CONSTRUCTION SUMMARY

Grovetrail Developments Inc.

LOT NUMBER	PHASE	HOUSE TYPE	CLOSING DATE
44	1	BELVEDEERE Elev B	09-Mar-22

Date Added: 23-Feb-22 Invoice Number: 7783

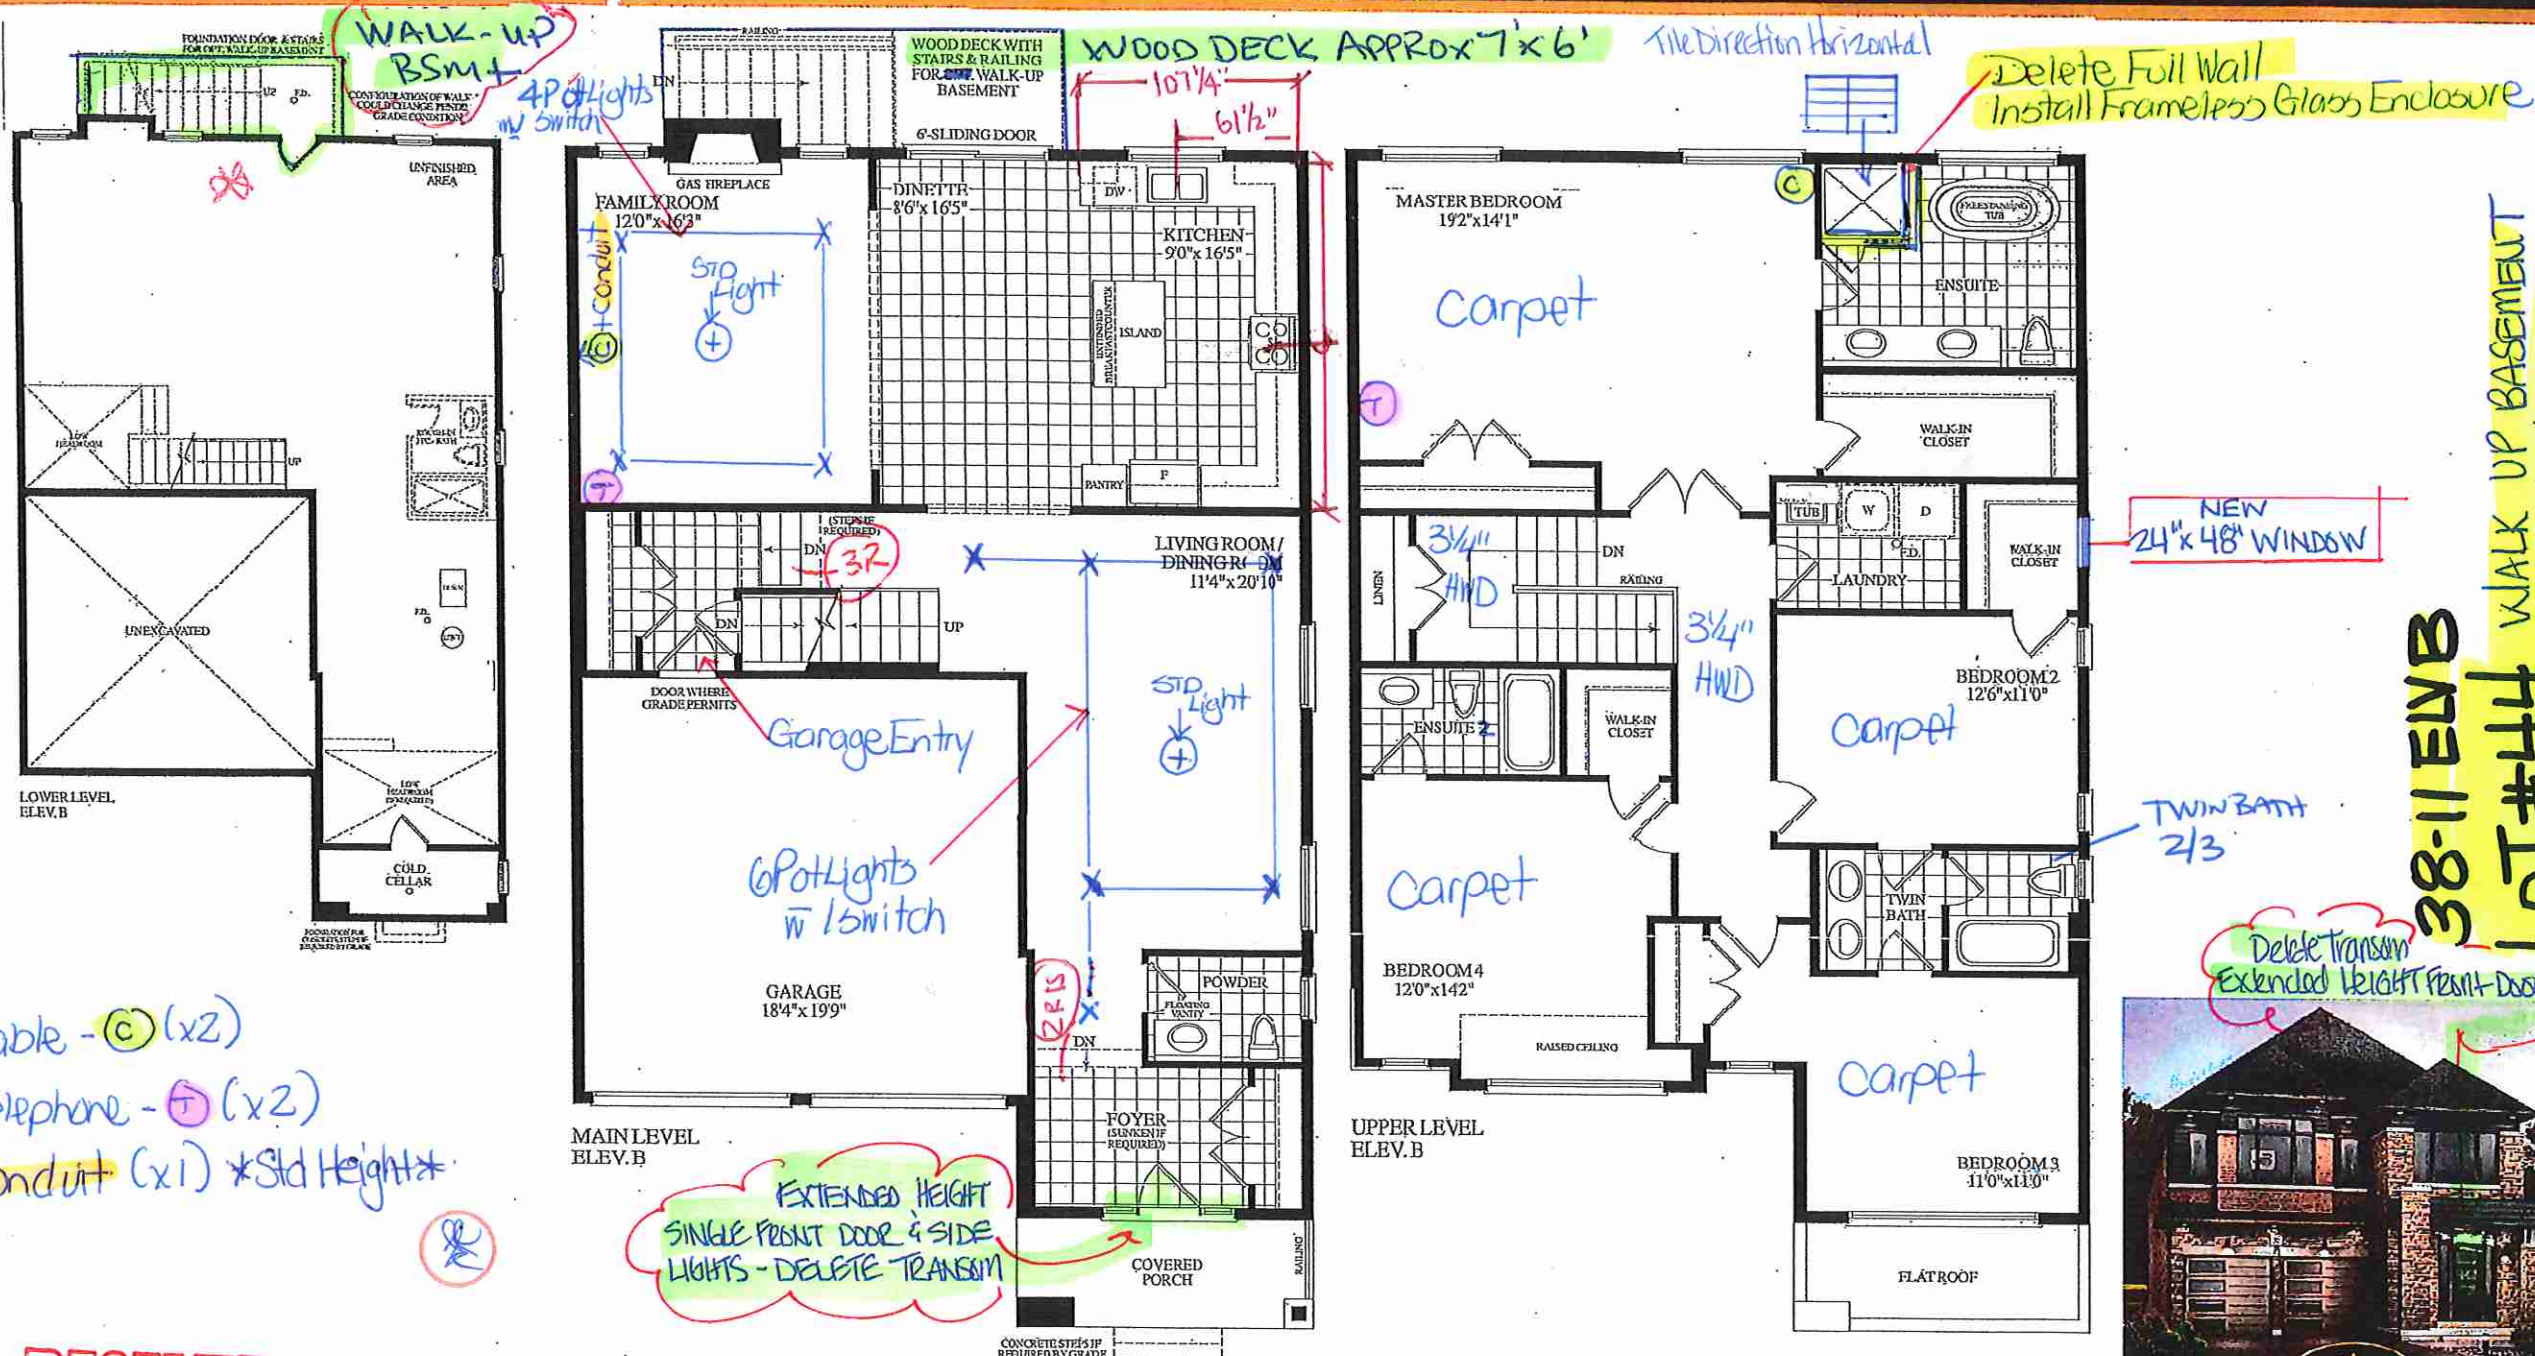
1 - Install Standard Cable Rough-Ins (x2) and Install Standard Telephone Rough-Ins (x2) (See Sketch) Note:
1 - DINING ROOM - Relocate builders standard ceiling light at dining room. To be installed centred at living room / dining room (See Sketch) Note:
1 - LIVING ROOM / DINING ROOM - In addition to builders standard ceiling light, Install SIX (6) LED POT LIGHTS with ONE (1) Separate Switch at living room / dining room (See Sketch) Note: **TEN (10) Pot Lights with ONE (1) Switch Included in Standard Features and Finishes**
1 - FAMILY ROOM - In addition to builders standard ceiling light, Install FOUR (4) LED POT LIGHTS with ONE (1) Separate Switch at family room (See Sketch) Note: **TEN (10) Pot Lights with ONE (1) Switch Included in Standard Features and Finishes** - Purchaser Paying for Additional Switch Only
1 - FRONT EXTERIOR - In addition to builders standard coach lights, Install SIX (6) EXTERIOR SOFIT LED POT LIGHTS with ONE (1) Seperate Switch. (See Sketch) Note:

cable - (C) (x2)
Telephone - (T) (x2)
conduit (x1) *Std Height*
